APPLICATION NO.	FILING DATE	FIRST NAMED INVENTOR	ATTORNEY DOCKET NO.	CONFIRMATION NO.
10/698,867	10/30/2003	George Paskalov	100798.0008US1	2026
24392	7590	08/22/2007		
FISH & ASSOCIATES, PC ROBERT D. FISH 2603 Main Street Suite 1050 Irvine, CA 92614-6232			EXAMINER WONG, EDNA	
			ART UNIT 1753	PAPER NUMBER
			MAIL DATE 08/22/2007	DELIVERY MODE PAPER

Office Action Summary	Application No. 10/698,867	Applicant(s) PASKALOV ET AL.	
	Examiner Edna Wong	Art Unit 1753

As shown in Applicants' Fig. 1:

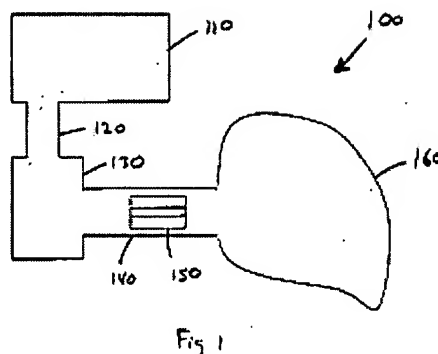
Applicants' specification, pages 1-6, does not mention without subjecting the waste directly to the plasma in the method. Thus, there is insufficient written description to inform a skilled artisan that applicant was in possession of the claimed invention as a whole at the time the application was filed.

However, there is sufficient written description for flowing the waste into conduit **140** where it is carried past the waves of the RF plasma generator **150** (page 4, lines 22-23). The conduit, which is substantially water tight, carries the fluid waste past the waves allowing it to be ***subjected to the waves*** for an amount of time that is sufficient to inactivate or kill a substantial amount of the microorganisms in the waste (page 5, lines 5-8).

the conduit **140** carries the waste in the vicinity of the RF plasma wave generator **150**. The waste would have been subjected directly to the waves produced by the RF plasma generator **150**.

The Examiner has carefully considered the entire specification as originally filed, however, there is found no literal support in the specification for the newly added limitation in amended claim 12. Applicants have not provided the page number and line numbers from the specification as to where the newly added limitations are coming from. *Ex parte Grasselli*, 231 USPQ 393 (Bd. App. 1983) *aff'd mem.* 738 F.2d 453 (Fed. Cir. 1984).
